# Temperature sensors on APAs

IFIC-Valencia

# Introduction

- Absolute length

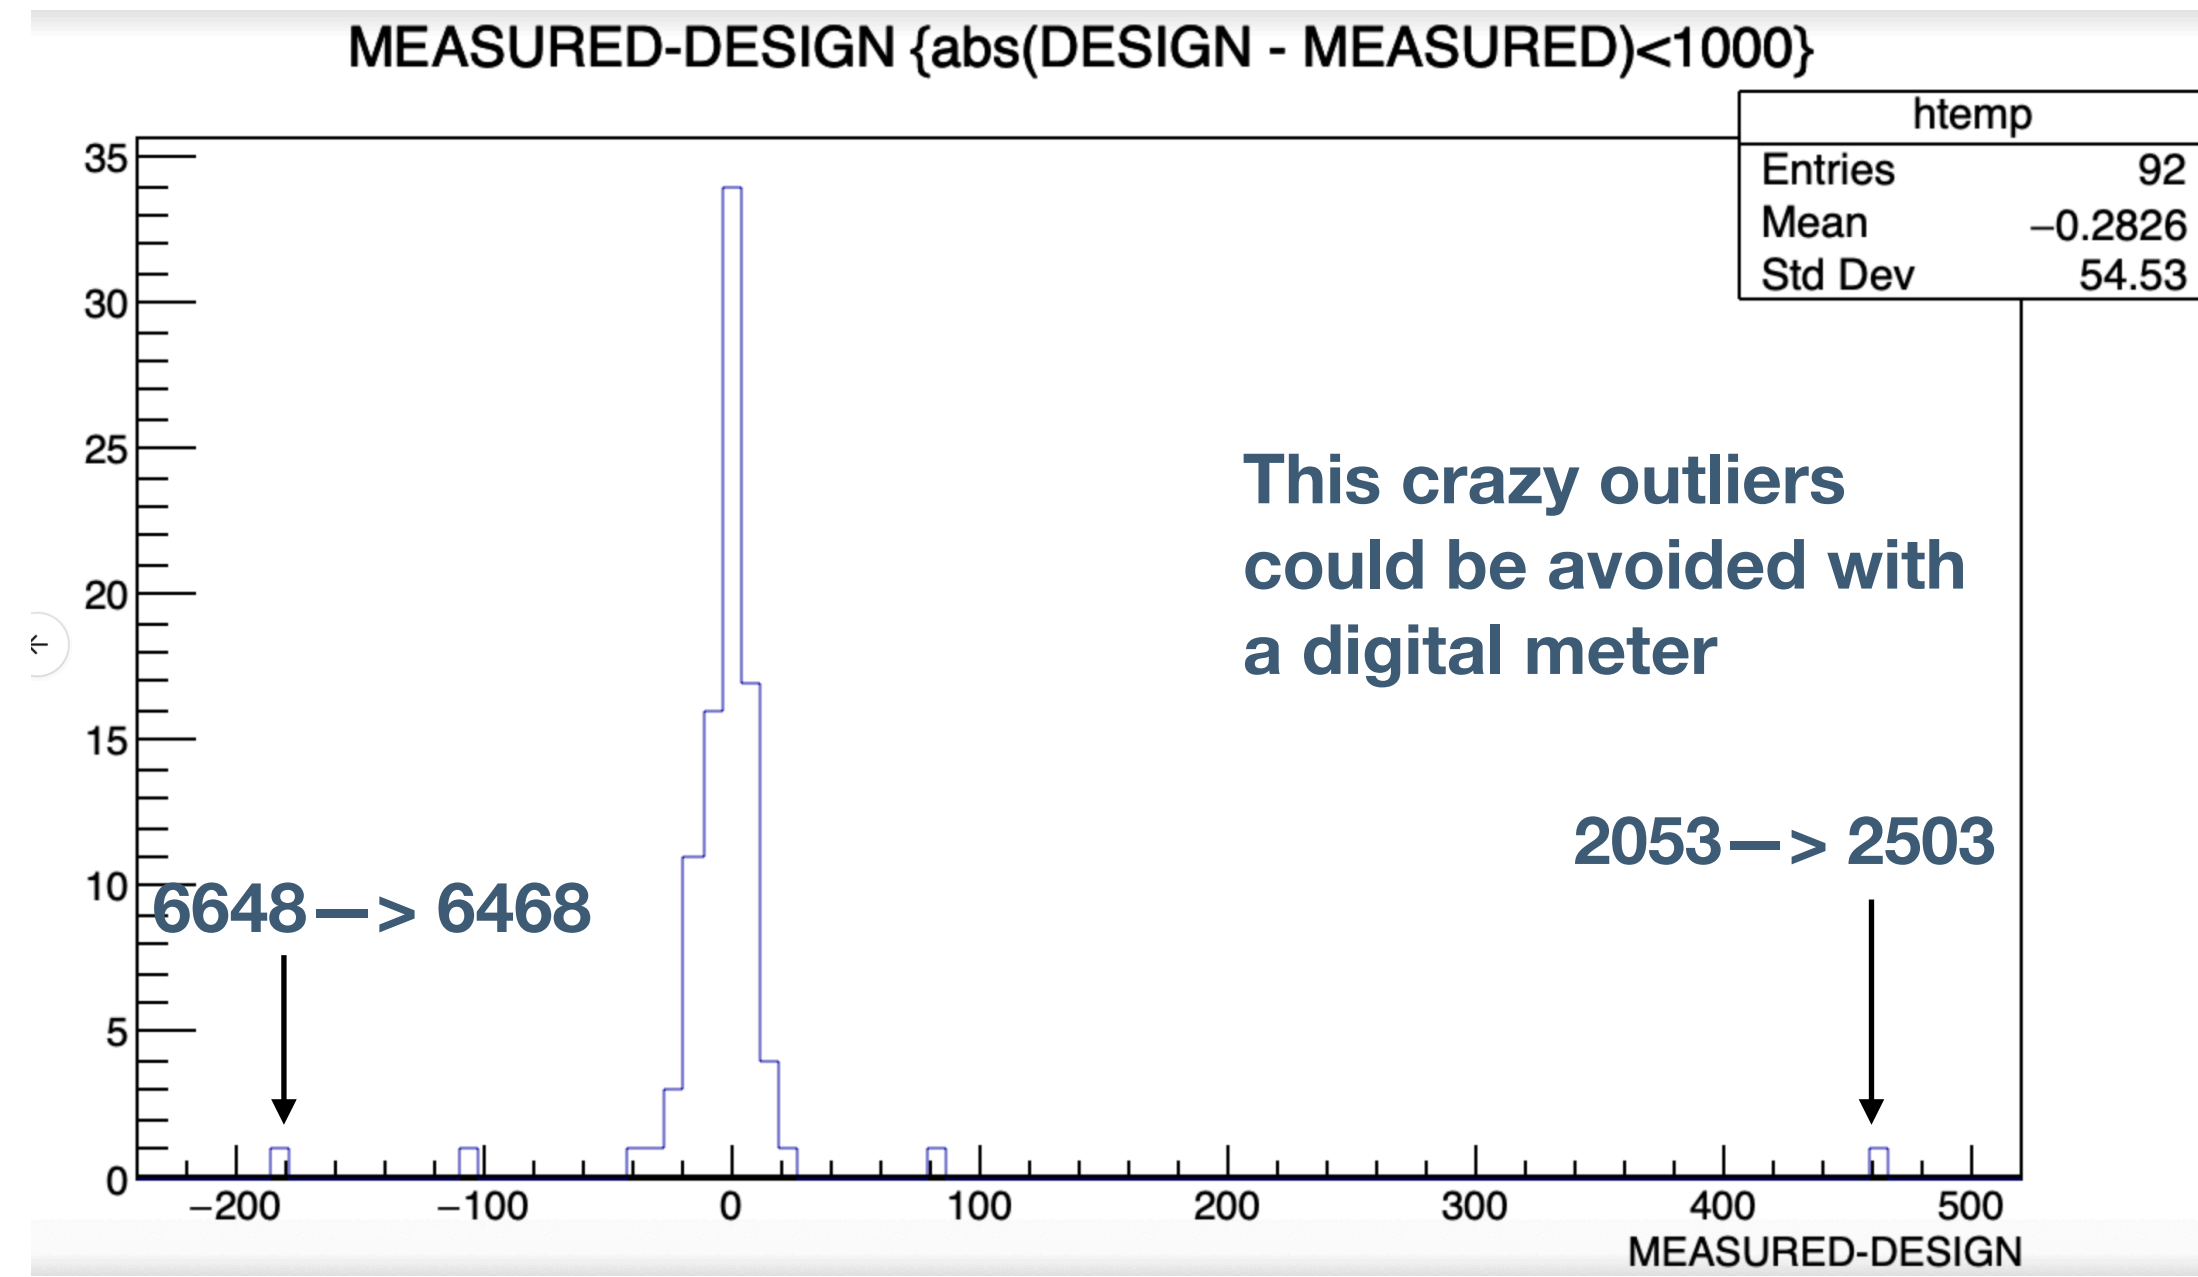
- Cables have 2% slack to account for contraction in cold
- When cutting, we used a 10m long tape measure on the floor
  - 0.5% tolerance is allowed
- We have cross-checked the lengths of 23 APA kits. Results available [here](#)

- 9 mm standard deviation on absolute length (removing outliers)
- This can be easily improved with a laser distance meter and better fixing tools

- Insufficient QC for cable lengths
- **Repair:** redo cables with lengths outside allowed range
- **Changes in production:** use a laser distance meter and proper fixing tools
- **Changes in QA/QC:** measure cables at several stages during production
  - When cutting them
  - After connectorising
  - Before packaging for shipment
